# LATIGO TRAILS FILING NO. 10

### PUBLIC UTILITY PLANS

PUBLIC UTILITY PLANS FOR:  
**LATIGO TRAILS**  
**FILING NO. 10**  
EL PASO COUNTY  
FALCON, COLORADO

ISSUE	DATE
INITIAL ISSUE	9/26/24

**CONESTOGA TR.**  
**WATER PLAN**  
**& PROFILE**

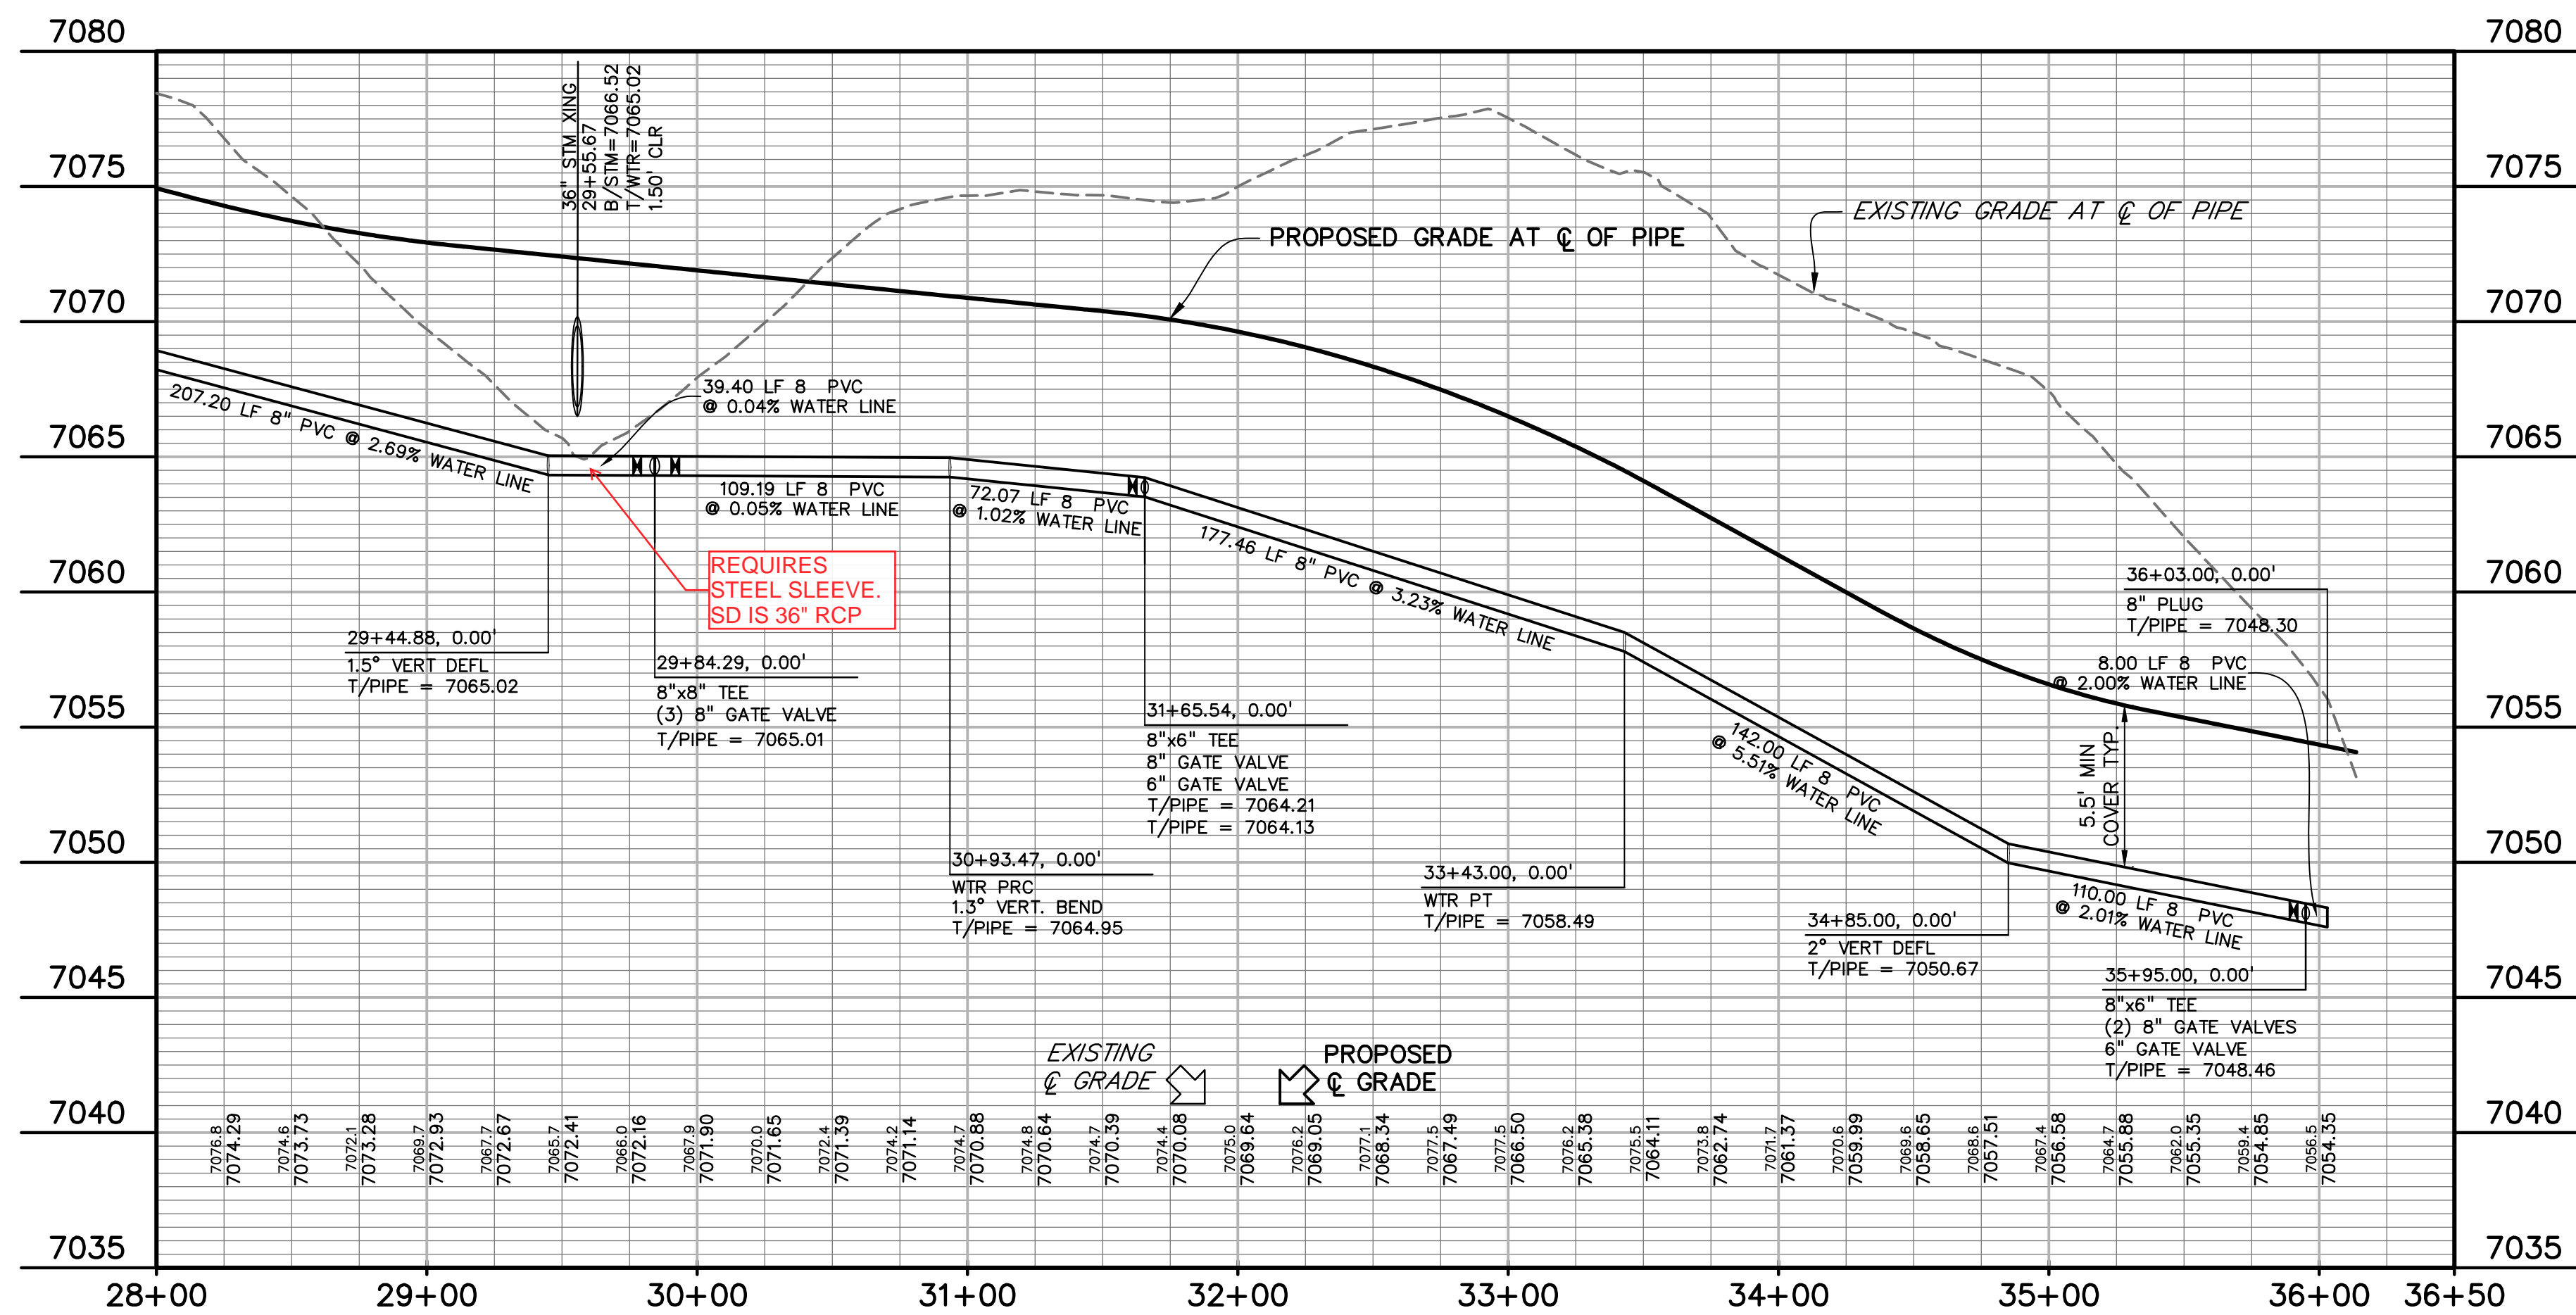
SEE SHEET...

LOW ??

LOW ??

REQUIRES STEEL SLEEVE. SD IS 36" RCP
